**Town of Pittsford Design Review & Historic Preservation Board  
AGENDA  
June 12, 2025**

**DESIGN REVIEW & HISTORIC PRESERVATION BOARD  
MINUTES  
MAY 22, 2025**

Regarding: Proposed Pittsford Oaks Market Rate Apartment House (Tobey PUD Parcels 8 & 12)

**RENDERING FROM INTERSECTION OF JEFFERSON RD & CLOVER ST**  
GRADE ALONG EAST FACADE AT +536'

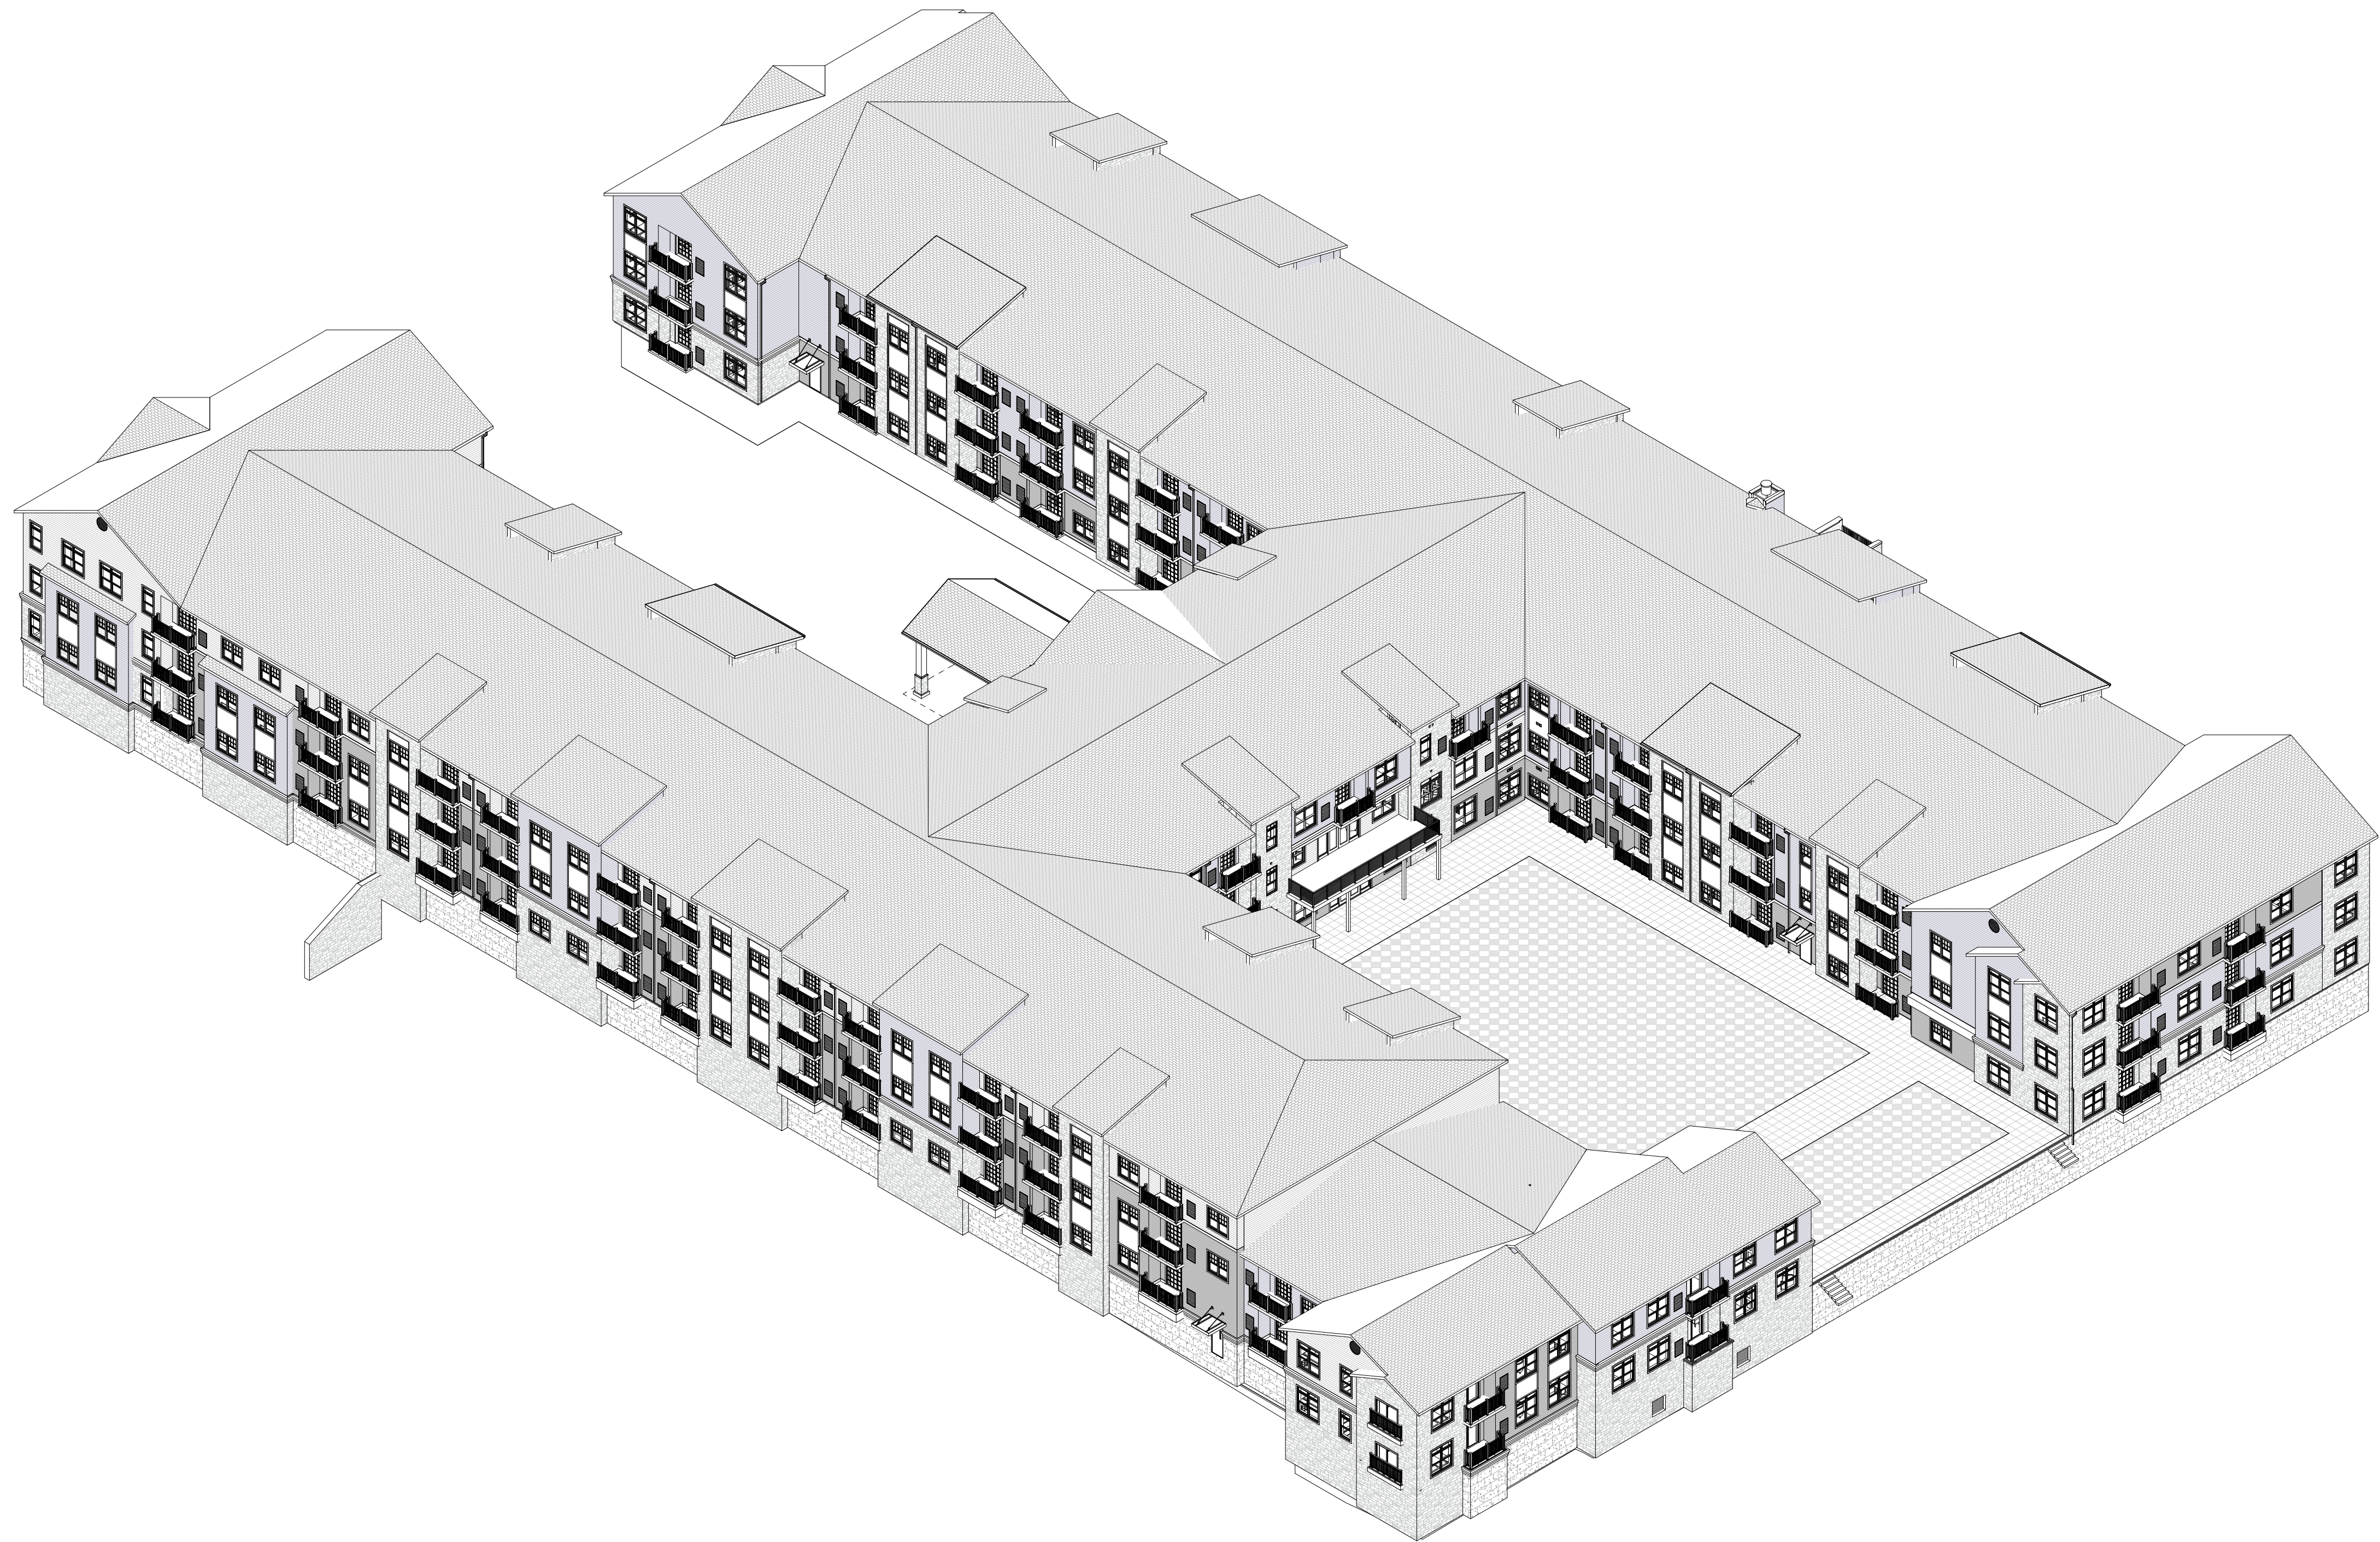
Applicant is requesting the review of design changes to date, the current design material, confirm the overall Northeast corner of the building height.

## Exterior Elevations and 3D Views The Terraces at Cloverwood

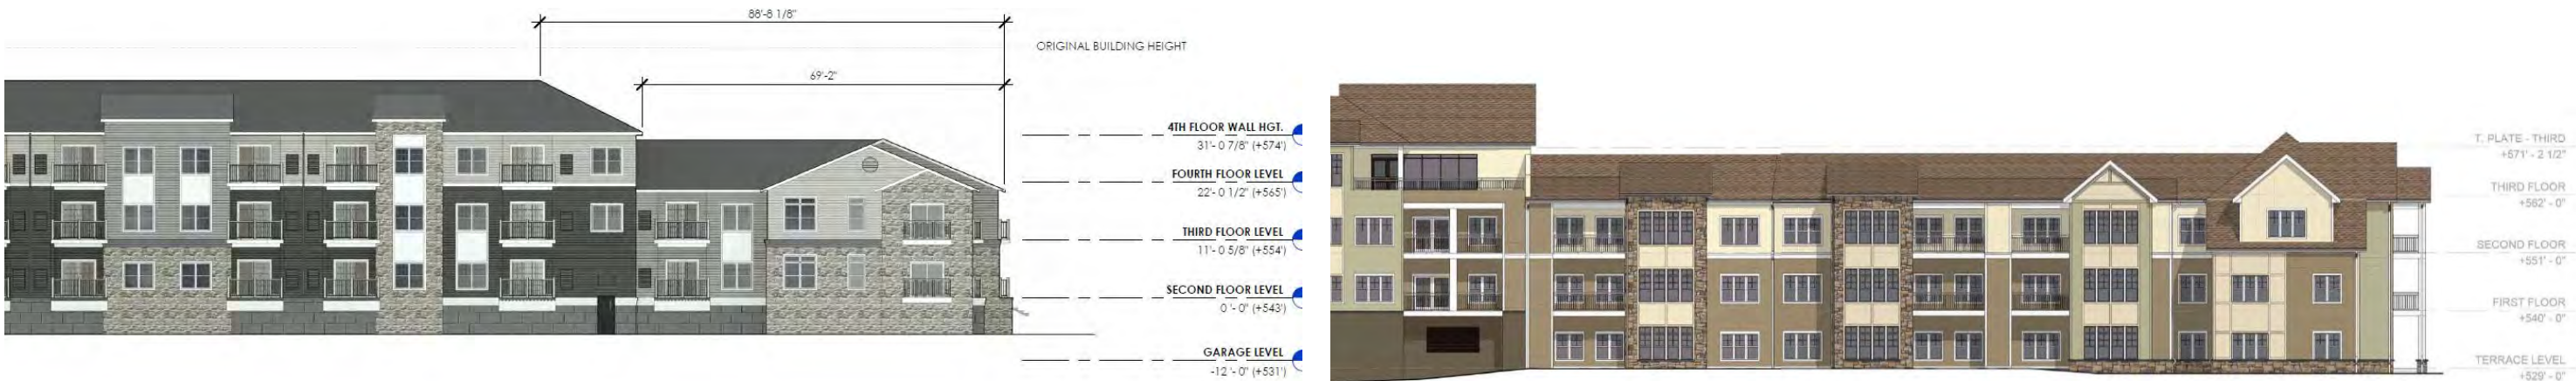
Third, as quoted above, the Planning Board has already suggested "a substantial reduction in the overall height of the eastern side of the building from behind the historic home to the northern end." Let's start with that.

Here is the suggestion: The roofline of the eastern elevation of the apartment building will mimic the Terraces at Cloverwood eastern elevation. The northeast leg will be reduced to the same u.s.g.s. roof elevation (571 feet) as the Terraces at Cloverwood design for a distance of 155 feet, which equals the same percentage of lowered roof as the Terraces at Cloverwood design. The remaining roofline going south will be similar to the height change of the Terraces at Cloverwood design, which is  $\pm 10$  feet. This will create a significant break in the roofline and will simulate the massing of the Terraces at Cloverwood project as viewed from the Clover and W. Jefferson intersection and from directly east of the project on Clover Street.
